CHANGE PROPOSAL REQUEST

Project Name: Riverside Public Defender/Probation Building Project
 EDA Project No. : FM08240003992
 PTC: Janus Corporation
 Contract No.: 011200.02
 PTC Address: 1081 Shary Circle
Concord, CA 94518

Item No. 01 Reference: Cost to demo two city vaults and two meter boxes owned by the city and not in Scope of Work. Extra work to demo sections of sidewalk added in the conformed set of drawings. Not in contract \$ 25,923.52
Justification: Conformed Set Changes and Added demo per City Inspector
Reference Documentation: Subcontact Change Order Request

DEMOLITION SITE PLAN

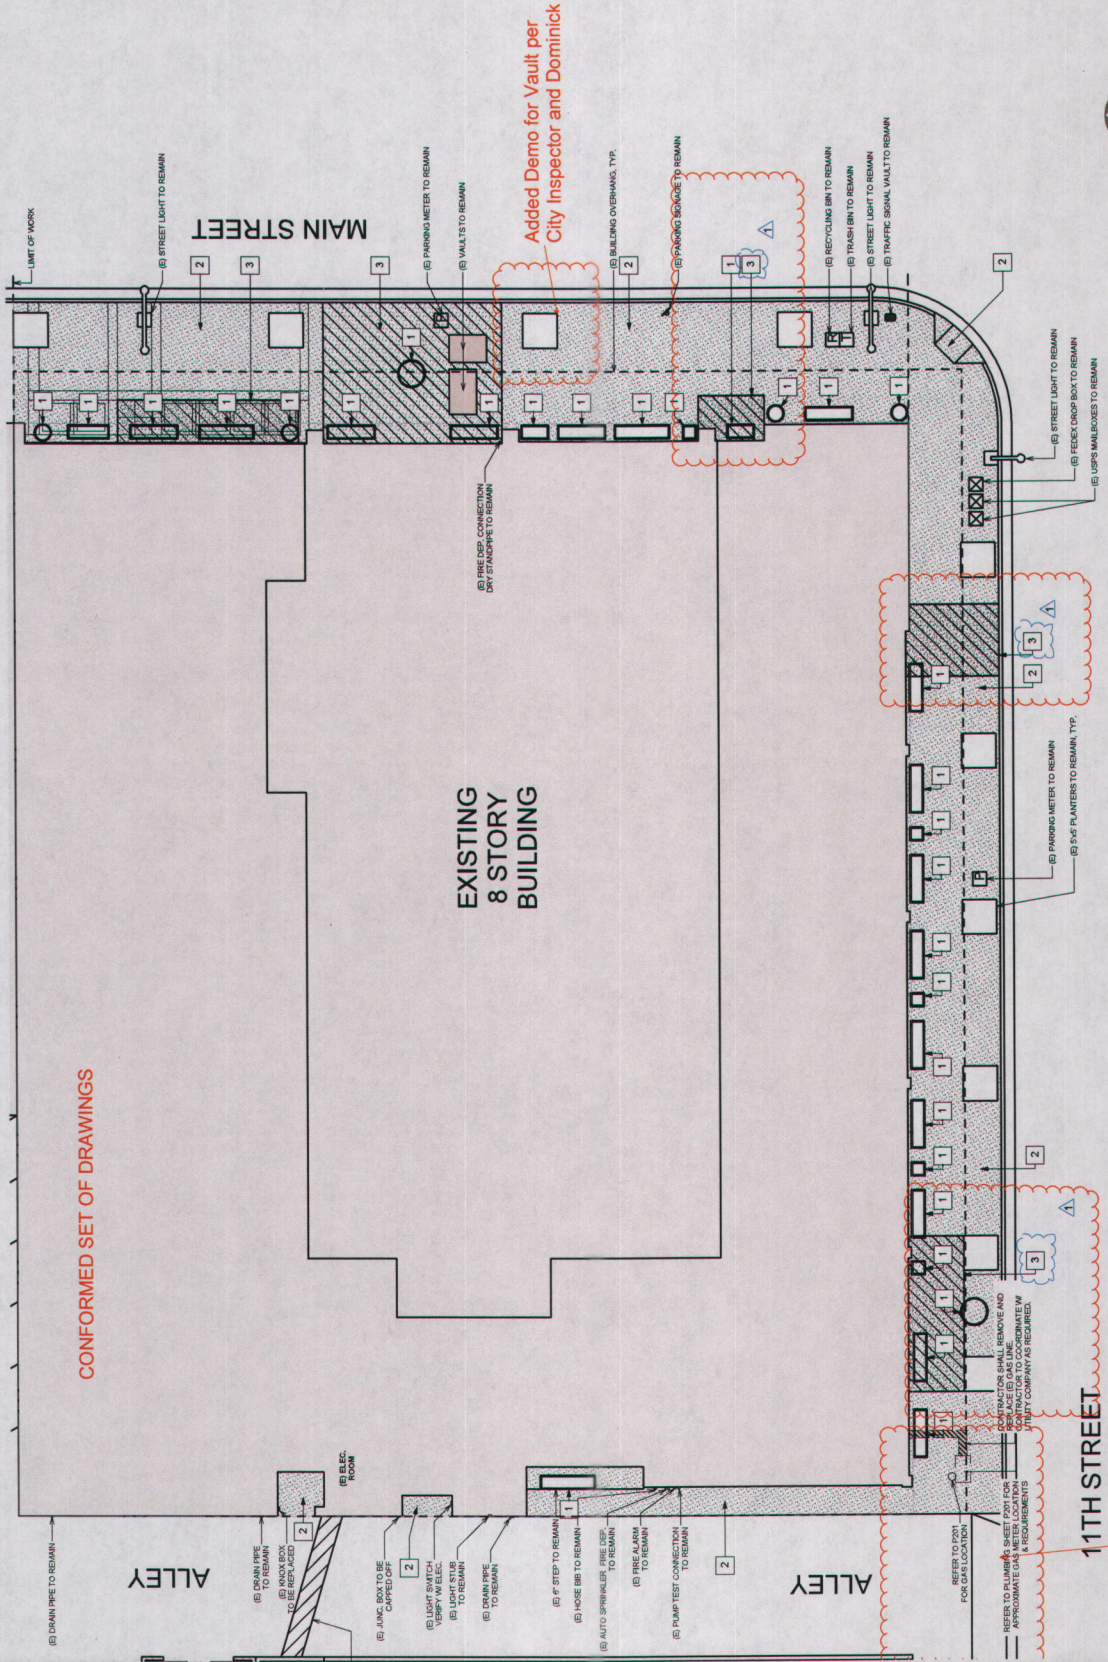
Added Demo for Vault per
City Inspector and Dominick

Added Demo per City Inspector
